City of El Paso – City Plan Commission Staff Report

Case No: SUSU12-00111 Mesquite Trails Unit Eight
Application Type: Major Preliminary
CPC Hearing Date: January 10, 2013
Staff Planner: Nelson Ortiz, (915) 541-4931, ortiznx@elpasotexas.gov
Location: South of Vista Del Sol and East of Joe Battle
Acreage: 16.94 acres
Rep District: 6
Existing Use: Vacant
Existing Zoning: R-3
Proposed Zoning: R-3
Nearest Park: Paseo Del Sol Park (.47 mile)
Nearest School: John Drugan Elementary School (0.84 mile)
Park Fees Required: N/A
Impact Fee Area: N/A
Property Owner: Americas Loop 375 Joint Venture
Applicant: Tropicana Development
Representative: CEA Group

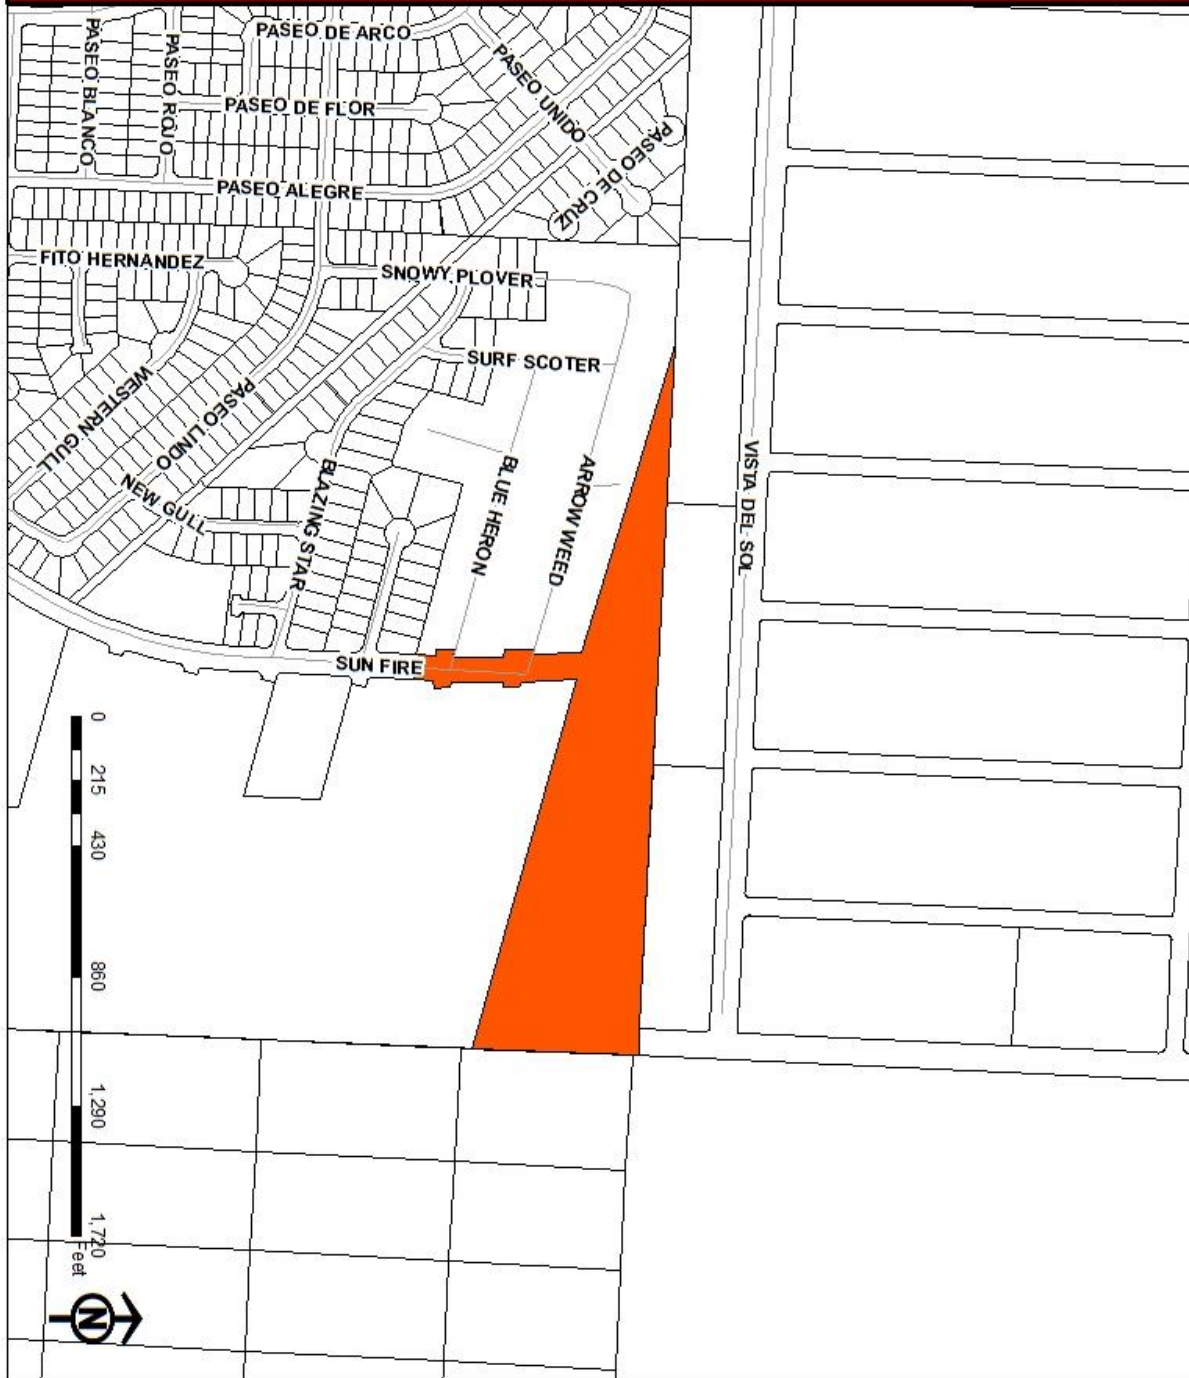
1. Red Robin Street shall be renamed as such name currently exists.
2. Specify party assigned to maintain the “Open Space” located in Lot 2 of Block 14 under restrictive covenants or on plat.
